DEPARTMENT OF ENVIRONMENTAL CONSERVATION

FIELD INSPECTION REPORT GREENS CREEK MINE

Inspection Date: October 11, 2007
Report Date: December 28, 2007
Weather: Cloudy. Temp 48°F., Wind 7mph with gusts to 21mph
Inspection Objectives: Routine inspection to follow up on informal site visits on May 30, 2007 and June 8, 2007
Operator Contact: Kerry Lear, Kennecott Greens Creek Mining Co. (KGCMC)
State Personnel: Ed Emswiler, ADEC Solid Waste Program
Kenwyn George, ADEC Wastewater Program
Other Personnel: Sarah Shoemaker, USDA Forest Service
Documentation: Photos were taken. Additional photos to those in this report are available from ADEC in Juneau

Figure 2: Pit 7: Note Hydroseed, Iron Stained Water and Constructed Wetland Treatment System

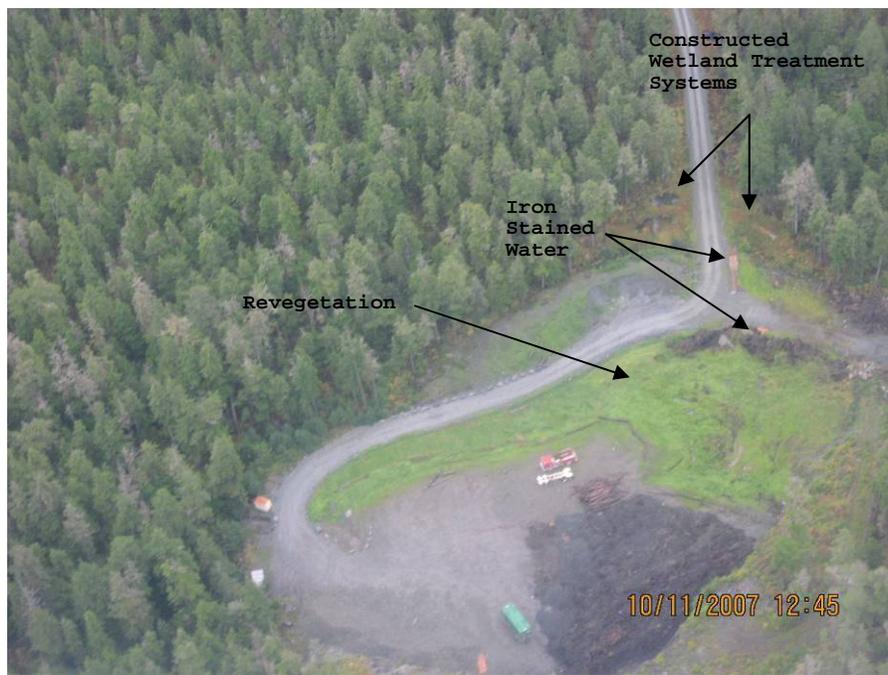
Iron staining was observed adjacent to road prisms and in water passing through stored overburden material (see Figure 3). The iron staining observed in the drainage from the pit is most likely due to dissolution of iron-rich oxide in the peat and gravel fill rather than from the pit walls (where iron staining has also been observed). Information from previous annual reports show relatively low sulfate concentrations and low metal values indicating limited sulfate oxidation.

Dissolution of iron and manganese oxides in the overburden stored in the pit has produced elevated concentrations of these metals and lead in the drainage.

Two small wetlands constructed at opposite sides of the road to the entrance of the pit treat the water before it enters a water of the U.S. One constructed wetland has two ponds (see Figure 4). Oxidation of the drainage waters and precipitation of the metals is expected in the constructed wetlands. Presently storm water monitoring occurs at the outlet to the wetlands. However, the water then runs down grassy ditch extensions of the constructed wetland areas which provide additional treatment prior to entering a small stream considered to be “waters of the U.S.” by EPA. EPA and Greens Creek are in the process of relocating the storm water compliance point to the outlet of the constructed wetland just prior to the discharge entering the stream.

1. Elevated lead concentration has been noted in drainages at Pit 7. Presently storm water is monitored within the constructed wetlands. EPA and Greens Creek are in the process of relocating the storm water compliance point to the outlet of the constructed wetland, just prior to the discharge entering the stream. Compliance with EPA stormwater benchmark values will be a point of interest in future evaluations.
